SCT Operations Pty Ltd

WCW05306

RESPONSE TO SUBSIDENCE RELATED SUBMISSIONS FOR MOD2 AT WONGAWILLI COLLIERY

Figure 1: Plan of Proposed MOD2 Layout relative to geological structure, existing mine workings and existing and proposed water infrastructure.

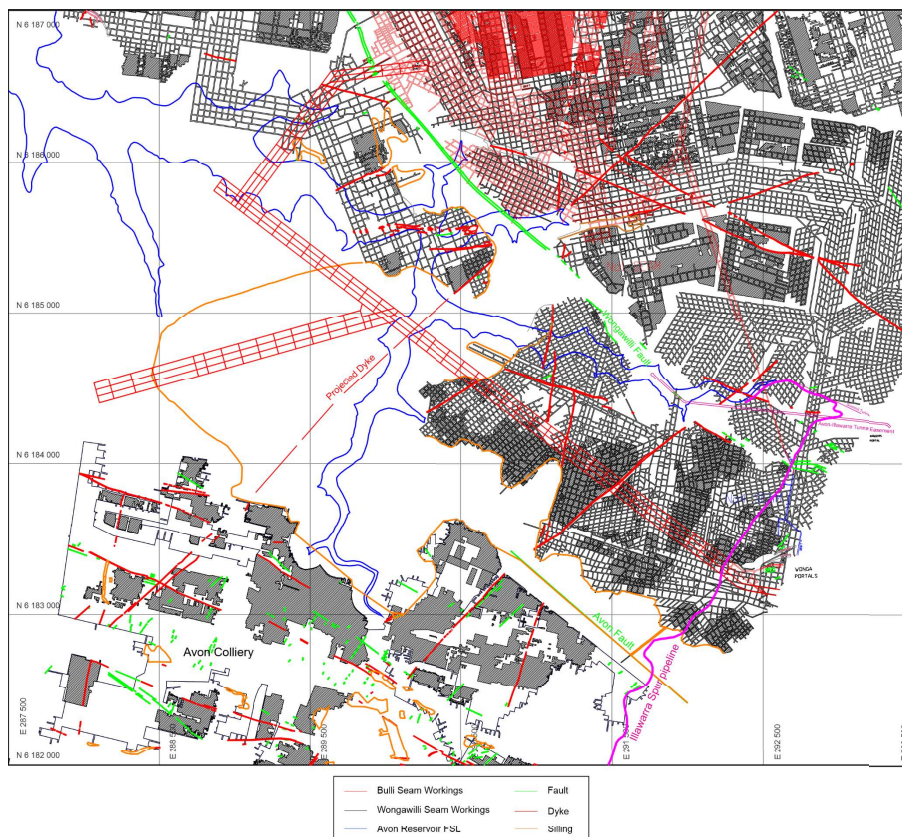
WaterNSW (2021) requested the potential for impacts to future water infrastructure, specifically the Burrawang to Avon tunnel, be considered. The only component of this proposed water security project, in the vicinity of the proposed MOD2 mining, is the Illawarra Spur pipeline from the upper reaches of Avon River to the Flying Fox No3 arm of the reservoir storage. This pipeline is design to traverse the surface along the route of existing fire roads, including Fire Road 15a, adjacent to the Moss Vale – Unanderra Railway.

Two headings of the MOD2 proposed layout would mine below where the pipeline would be constructed. Two headings of the NW Mains already exist at this location at a depth of 170m below the proposed pipeline route.

No impacts to this proposed pipeline are expected from the mining proposed in MOD2.

Figure 2: Exposure of the Wongawilli Fault Plane at start of drift driveage.

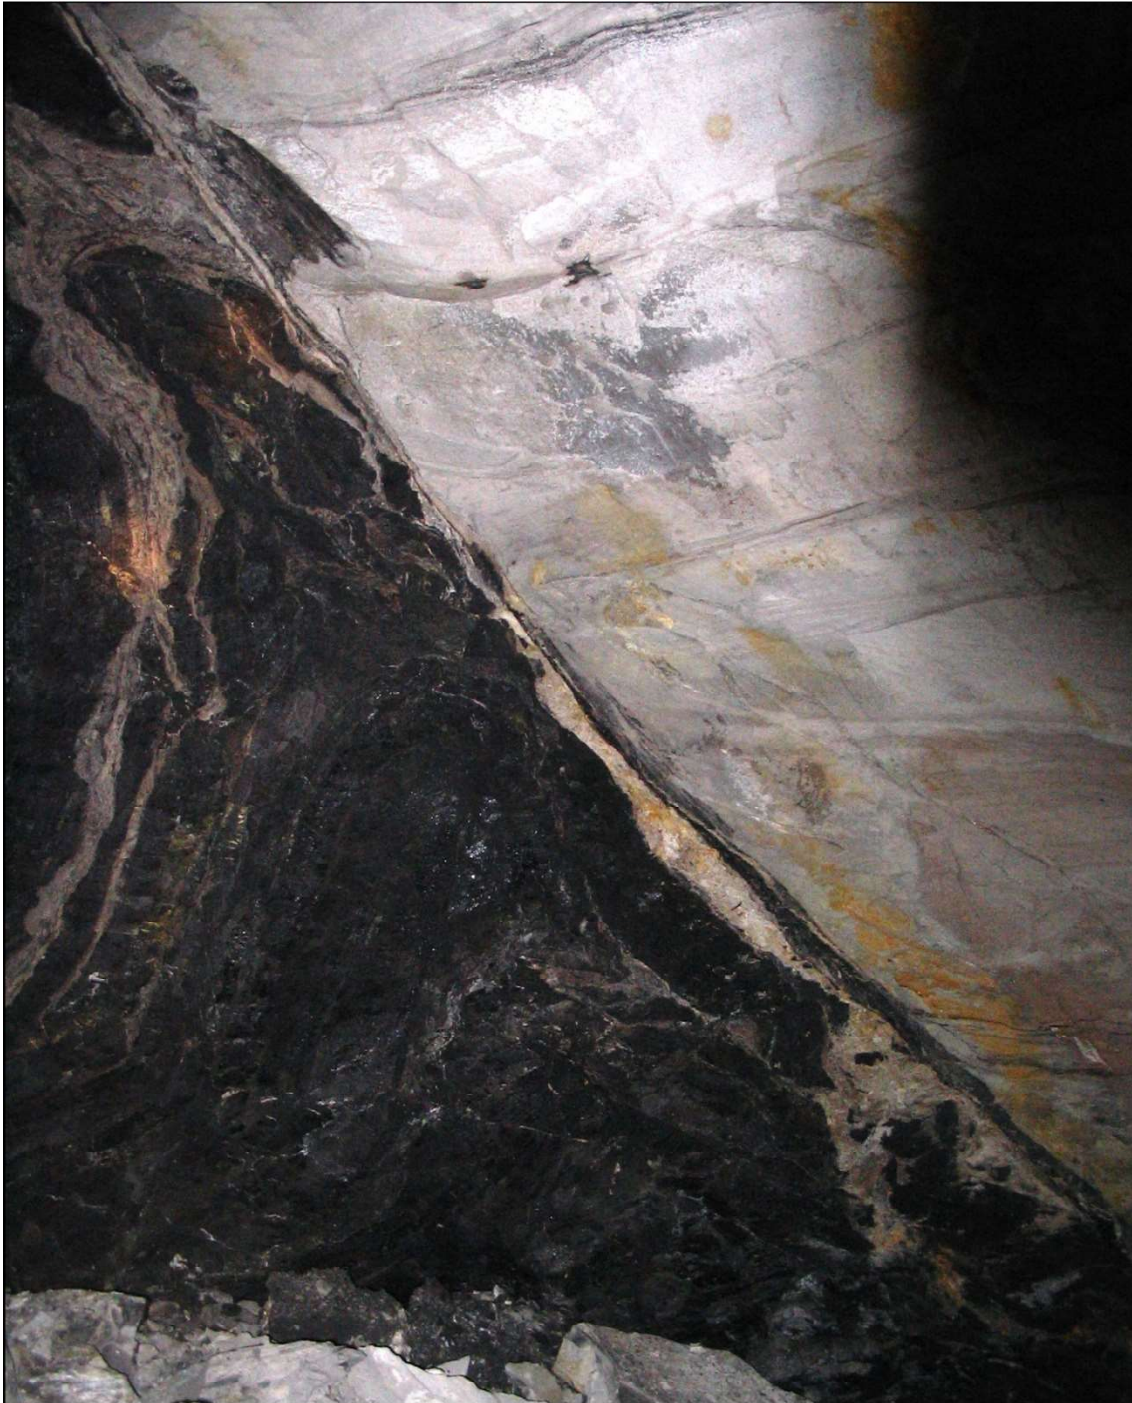
WaterNSW (2021) has requested further consideration of the impact of mining through the Wongawilli Fault and the dyke located below Avon Reservoir. The potential for inflow through these structures is discussed in Section 6 of SCT (2020).

Historical mining at Wongawilli and Elouera Colliery has driven ten cross-measures drifts through the Wongawilli Fault. Figure 2 shows an exposure of the Wongawilli Fault plane at the start of one of these driveages where the downthrow of the fault is approximately 12m.

There are also many intersections of the fault plane(s) or steeper ground associated with the fault from everyday driveages in both the Wongawilli and Bulli Seams. Some of these intersections are in close proximity to where the Wongawilli Fault crosses the reservoir in the Flying Fox No1, No2 and No3 arms of the storage. No significant inflows have been observed from the drifts or other intersections of the Wongawilli Fault.

It is anticipated that the ground conditions where the proposed headings cross the Wongawilli Fault will be able to be managed without undue difficulty. The coal mining and Avon-Illawarra Tunnel driveage experience supports this expectation. The crossing point for the proposed headings is approximately 400m from the FSL of Avon Reservoir. No interaction effects with the reservoir are expected.
